**SUBDIVISION &  
ZONING AMENDMENT STAFF REPORT****Date: July 7, 2016**

<b><u>APPLICANT NAME</u></b>	Bean Properties, LLC
<b><u>SUBDIVISION NAME</u></b>	Bean Commercial Subdivision
<b><u>LOCATION</u></b>	North side of Todd Acres Drive, 700'± North of Kooiman Road
<b><u>CITY COUNCIL DISTRICT</u></b>	Council District 2
<b><u>PRESENT ZONING</u></b>	R-A, Residential-Agriculture District and B-5, Office-Distribution District
<b><u>PROPOSED ZONING</u></b>	I-2, Heavy Industry District
<b><u>AREA OF PROPERTY</u></b>	1 Lot/27.1± Acres
<b><u>CONTEMPLATED USE</u></b>	Subdivision Approval to create a single legal lot of record from two metes-and-bound parcels; and Rezoning from R-A, Residential-Agriculture District and B-5, Office-Distribution District, to I-2, Heavy Industry District, to allow the construction of a warehouse to house a steel service center and eliminate split zoning. <b>It should be noted, however, that any use permitted in the proposed district would be allowed at this location if the zoning is changed. Furthermore, the Planning Commission may consider zoning classifications other than that sought by the applicant for this property.</b>

# DETAIL SITE PLAN

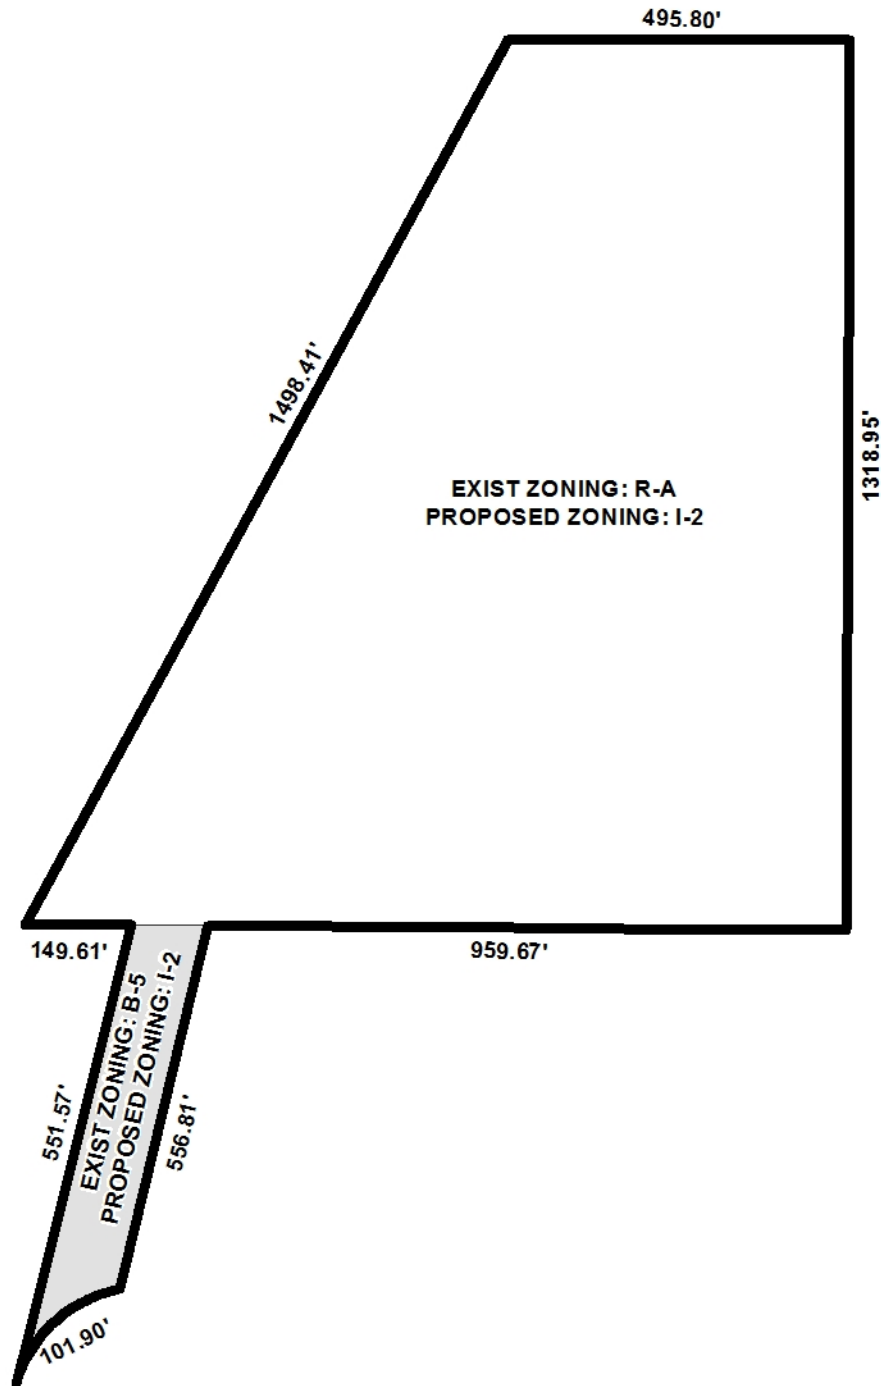
The preliminary plat does illustrate the 25' minimum building setback at the end of the pole. If approved, this information should be retained on the Final Plat as well.

There is a 7.5' water & sewer easement illustrated along the Eastern property line that, according to Probate Court documents, has been vacated since 1977, therefore the easement should not be shown on the Final Plat.

The proposed site plan indicates that a dumpster will not be provided on the site, and that garbage pickup will be via curb side pickup.

The site plan submitted indicates a 36,250 square foot structure with 1,200 square feet of office space and 35,050 square feet of warehouse space. No information is provided about the number of warehouse employees, but the site plan does indicate that 7 parking spaces are required and that 7 parking spaces will be provided. If approved, the site plan for permitting should be revised to indicate the number of warehouse employees at the site so that staff can verify 7 spaces will be sufficient.

The site plan also indicates an outside storage and truck maneuvering area that is proposed to have aggregate surfacing.

- 1) provision of the lot size in square feet and acres;
- 2) retention of the 25' minimum building setback line;
- 3) placement of a note on the site plan stating that the lot is limited to one curb cut to Todd Acres Drive, with size, location and design to be approved by Traffic Engineering and conform to AASHTO standards;
